City of Corpus Christi

Meeting Agenda - Final

Planning Commission

Wednesday, October 15, 2025

PLAT OF BLUFF ADDITION BLOCK 3, LOTS 1R & 2R

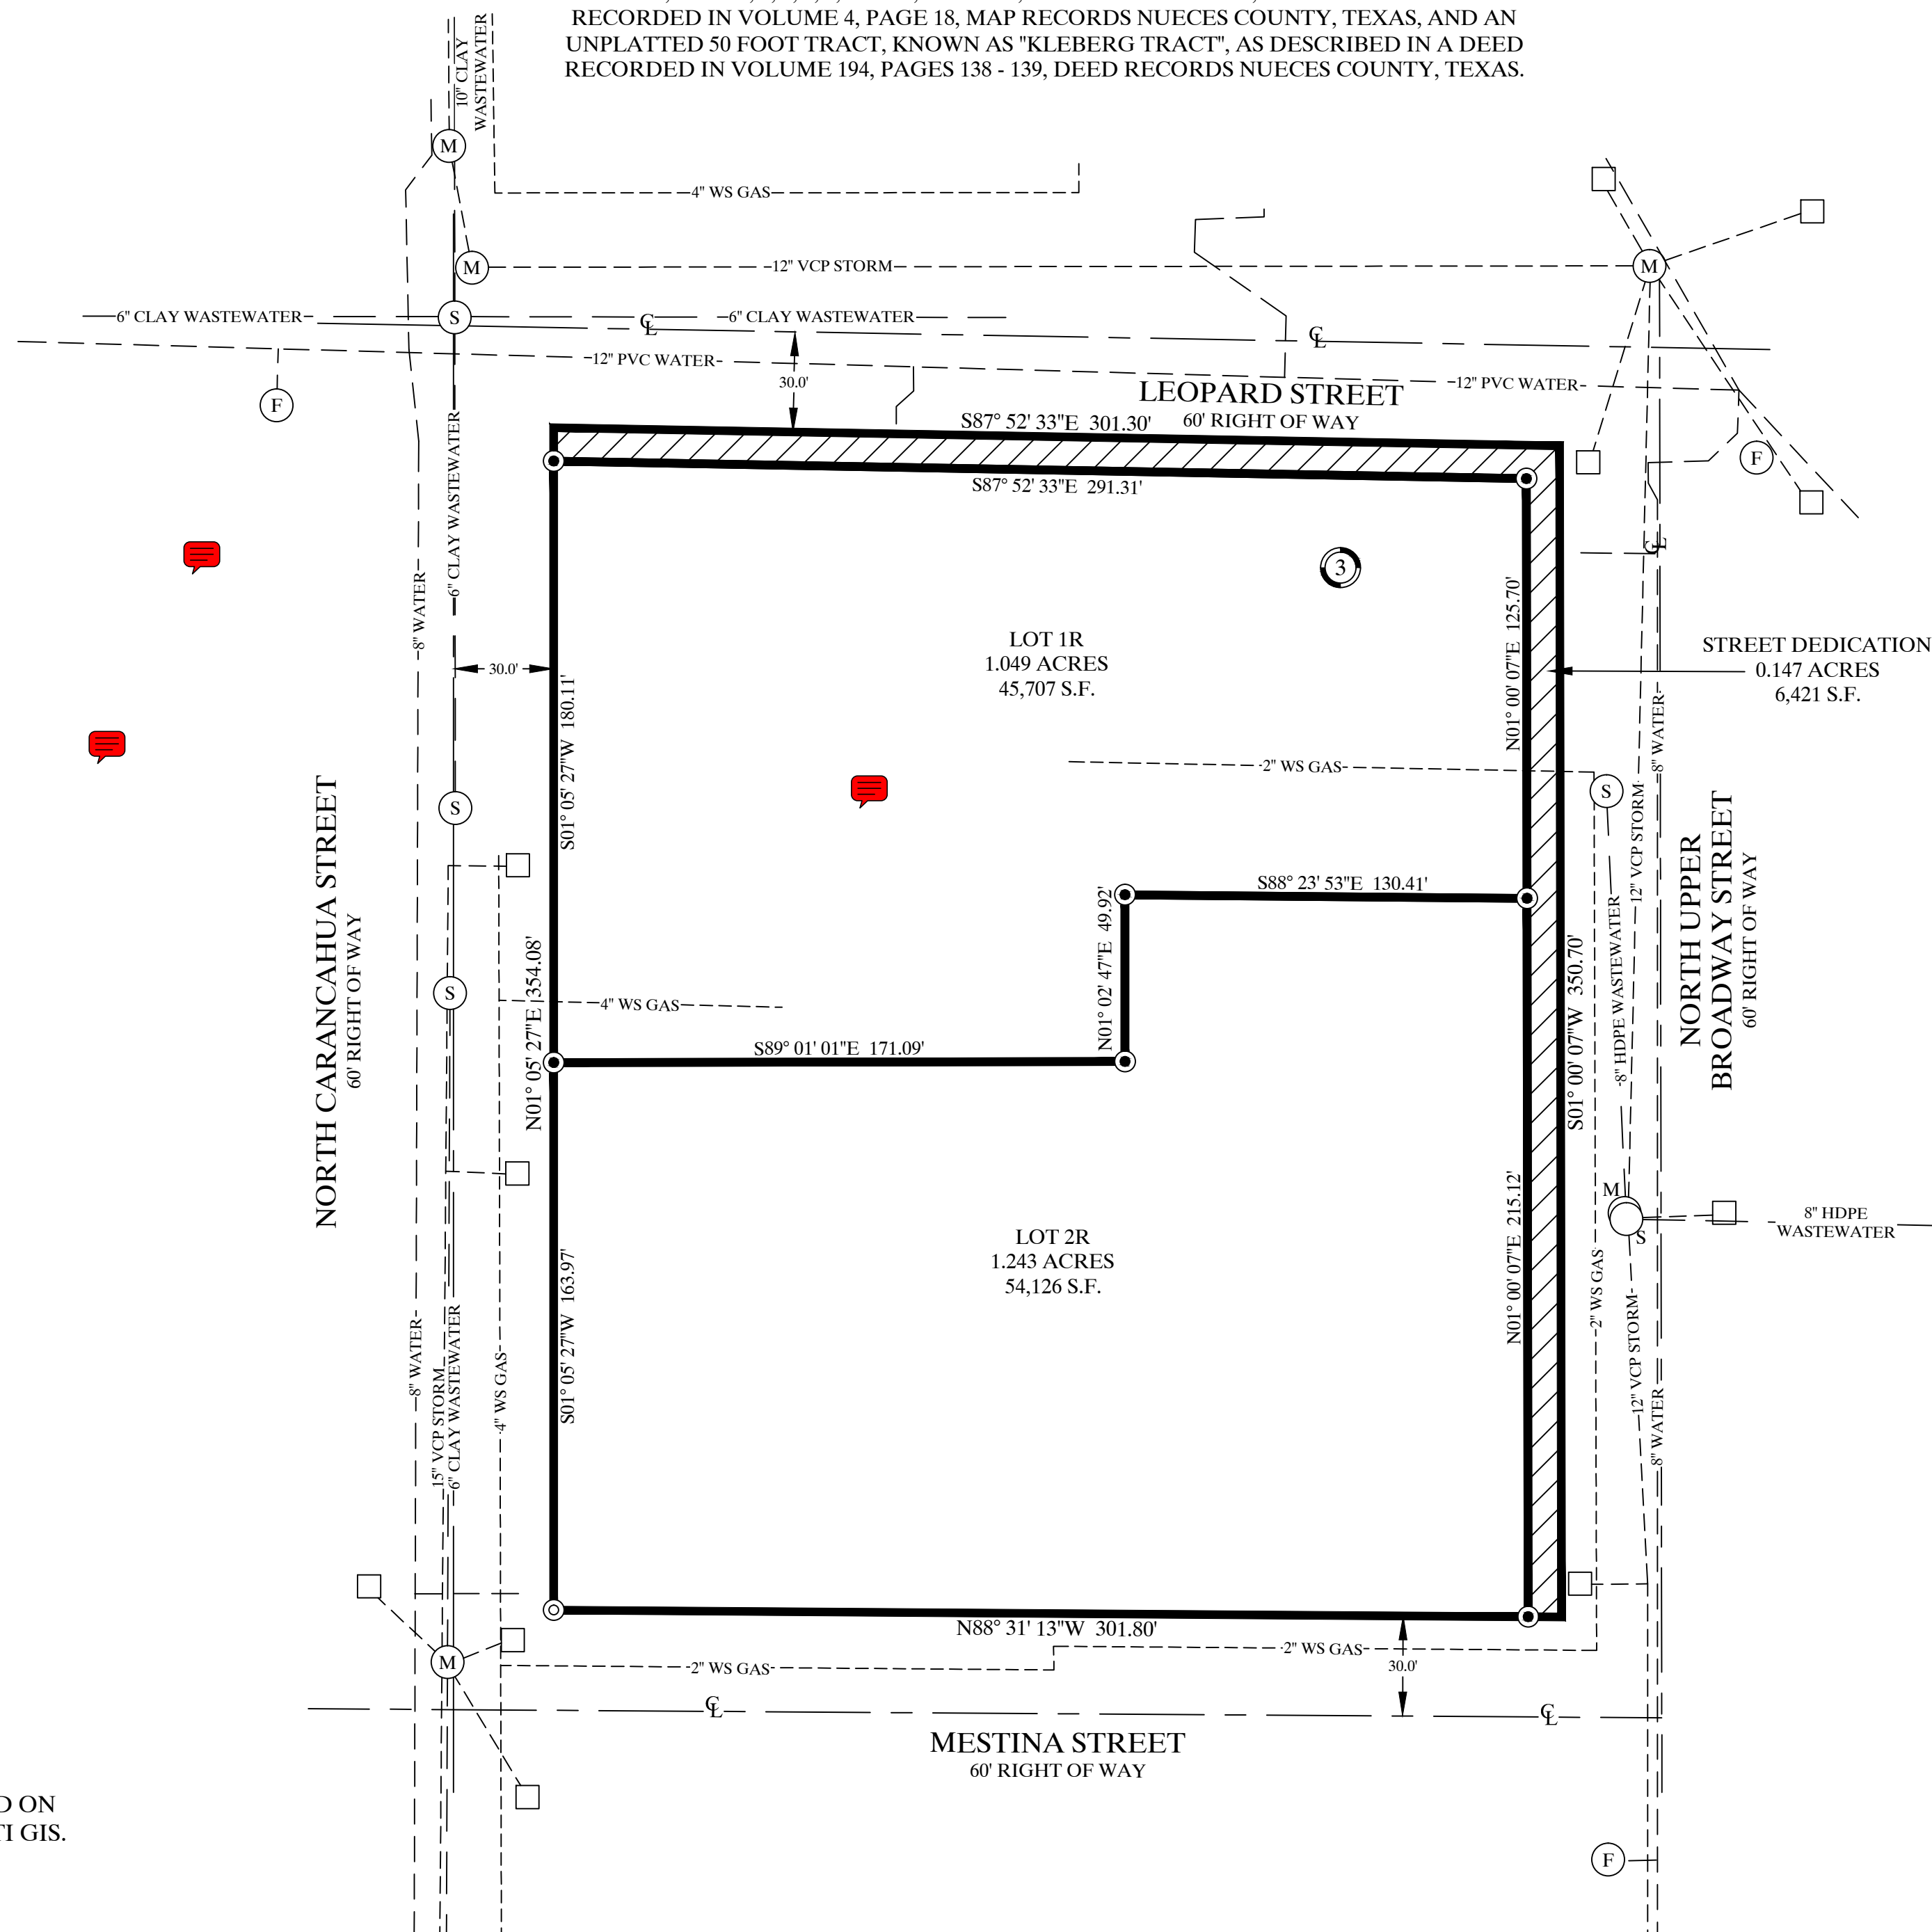
Comment ID	Author : Department	Status	Review Comments	Applicant Response Comments
3	Alex Harmon : DS	Closed	<p>Improvements Required for Recordation, per UDC 8.1.4.</p> <p>A. Streets: No Sidewalks: No B. Water: No Fire hydrants: Potentially at site development depending on building footprints. C. Wastewater: No D. Stormwater: No E. Public open space: No F. Permanent monument markers: No</p> <p>Please note, improvements required should be constructed to city standards, found in Article 8 and the IDM.</p>

Comment ID	Page Reference	Annotation Type	Author : Department	Status	Review Comments	Applicant Response Comments
1	P001	Note	Mina Trinidad : DS	Closed	This Plat Application has requested the 30-day review tract. Please keep in mind that once the Technical Review Committee (TRC) comments are sent back to you, you will have the option to request additional review time (if needed). If you do not request additional review time, your application will be sent to Planning Commission with open comments from TRC.	
2	Utility Plan	Note	Alex Harmon : DS	Closed	Provide and show 5' utility easements on the plat for gas lines shown on Lot 1R.	
4	P001	Note	Mark Zans : LD	Closed	<p>Please see below the Traffic / ROW comments for the above subject project(s). All comments informational</p> <ul style="list-style-type: none"> □□Proposed Driveway access to public City Street shall conform to access management standards outlined in Article 7 of the UDC (UDC 7.1.7) o□The developer / applicant can reach out to rowmanagement@cctexas.com for further assistance regarding the ROW Construction Permit they will be required to submit prior to any temporary and / or permanent driveway off the immediate roadways. o□The ROW Construction permit must be submitted and approved prior to any form of construction within City ROW. o□Any contractor working within City ROW without an approved ROW Construction Permit can be held in non-compliance and can be subject to a fee of \$1,500 per day of unpermitted work, as per City of Corpus Christi Municipal Code 49-112 (9).

7	P001	Note	Mark Zans : LD	Closed	<p>Fire comments #1</p> <p>1□Plat□Note: All code reference is based on currently adopted International Fire Code (IFC)</p>

5	Utility Plan	Note	Justin Phung : STREET	Closed	<p>PW STR: Informational - Please refer to City of Corpus Christi Standards and Specifications for proposing roadwork, curb and gutter, sidewalk, utilities, etc and have the standards included in the plan set and the specifications referenced. Wherever available, please include a table of contents for which standards and specifications were used.</p>	
6	Utility Plan	Note	Justin Phung : STREET	Closed	<p>PW STR: Informational - A person shall be held responsible for damage to and in public right-of-way for the criteria outlined in Sec. 49-39-9 in the City's Municipal Code and will be held responsible for restoring the City assets per Municipal Code Sec. 49-47-1, Sec. 49-54-6 and Sec. 49-49-3. For further information, please email ROWManagement@cctexas.com.</p>

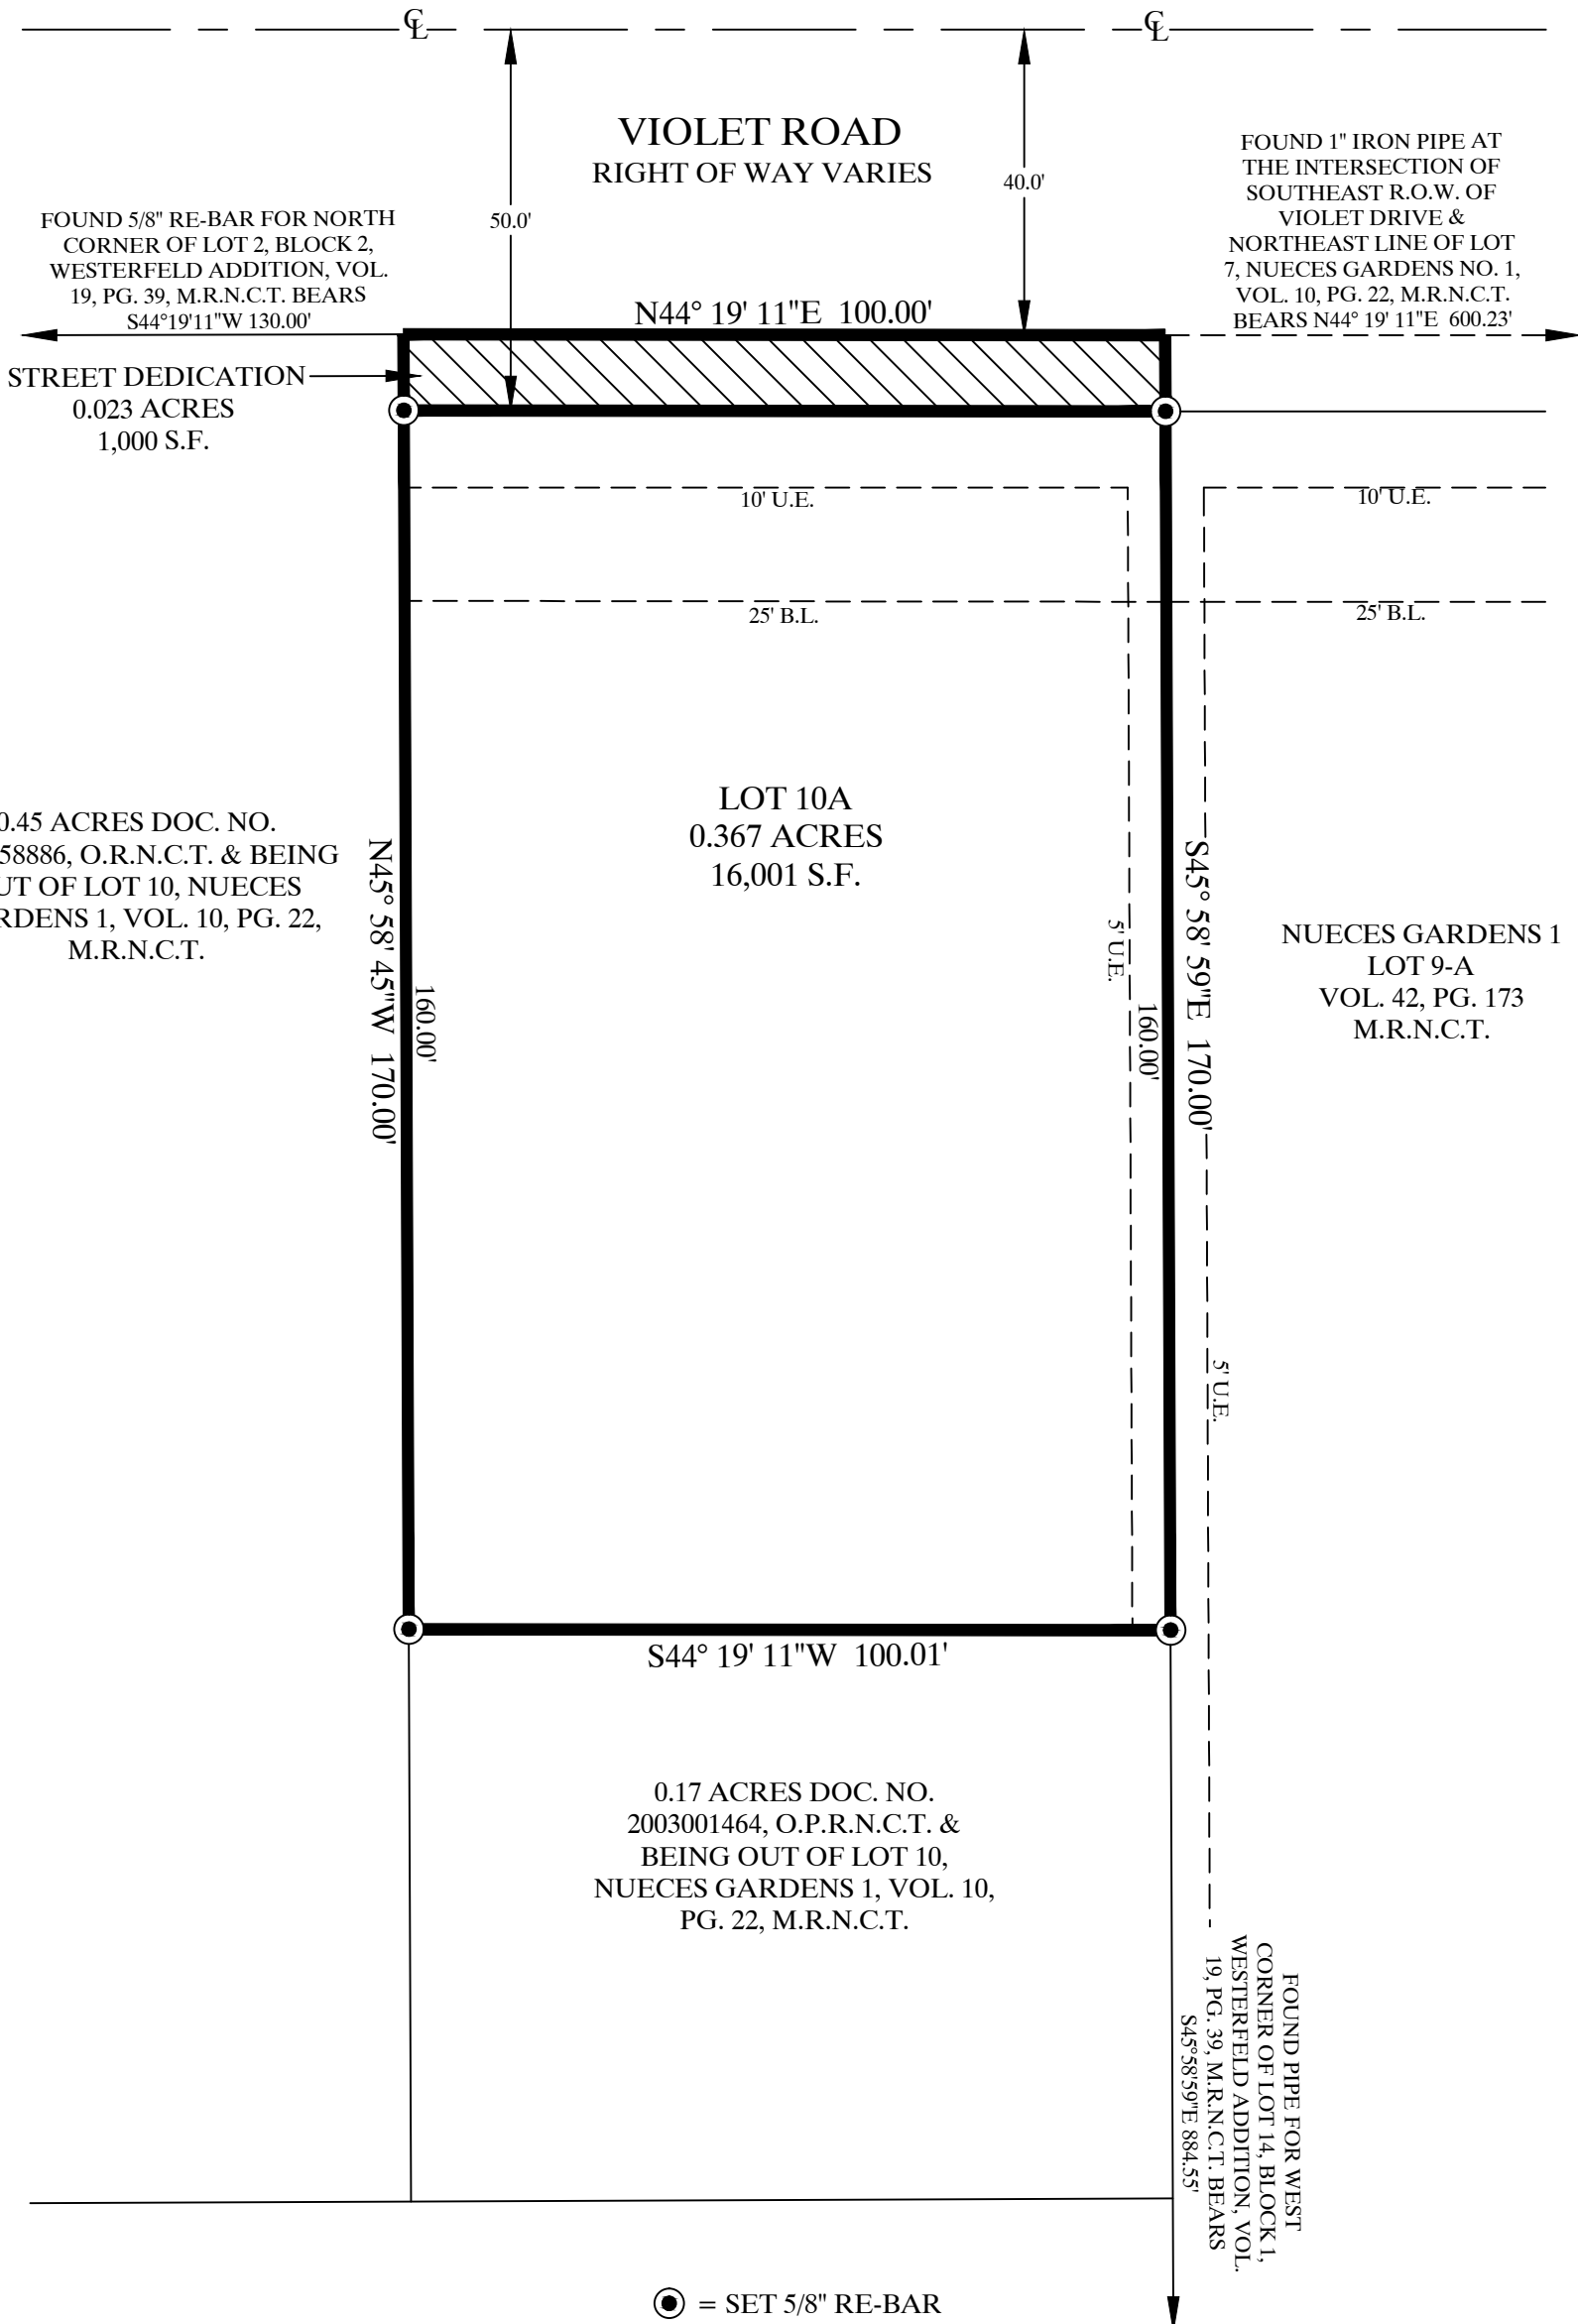
Comment ID	Author : Department	Status	Review Comments	Applicant Response Comments
7	Alex Harmon : DS	Closed	Improvements Required for Recordation, per UDC 8.1.4. A. Streets: No Sidewalks: No B. Water: No Fire hydrants: No C. Wastewater: No D. Stormwater: No E. Public open space: No F. Permanent monument markers: No Please note, improvements required should be constructed to city standards, found in Article 8 and the IDM.

Comment ID	Page Reference	Annotation Type	Author : Department	Status	Review Comments	Applicant Response Comments
1	Plat1	Note	Mina Trinidad : DS	Closed	This Plat Application has requested the 30-day review tract. Please keep in mind that once the Technical Review Committee (TRC) comments are sent back to you, you will have the option to request additional review time (if needed). If you do not request additional review time, your application will be sent to Planning Commission with open comments from TRC.	
3	Plat1	Note	Alex Harmon : DS	Closed	Verify and acknowledge centerline to property line is 50 ft. This is what it should be for an A2, however, measurements on city data are 45 ft. It is recognized that city data is not always the most up to date.	
8	Plat1	Note	Mark Zans : LD	Closed	Park Fee: 1 x 462.50 = \$462.50	
5	Plat1	Note	Caleb Wong : STREET	Closed	PW STR: Informational - Please refer to City of Corpus Christi Standards and Specifications for proposing roadwork, curb and gutter, sidewalk, utilities, etc and have the standards included in the plan set and the specifications referenced. Wherever available, please include a table of contents for which standards and specifications were used.
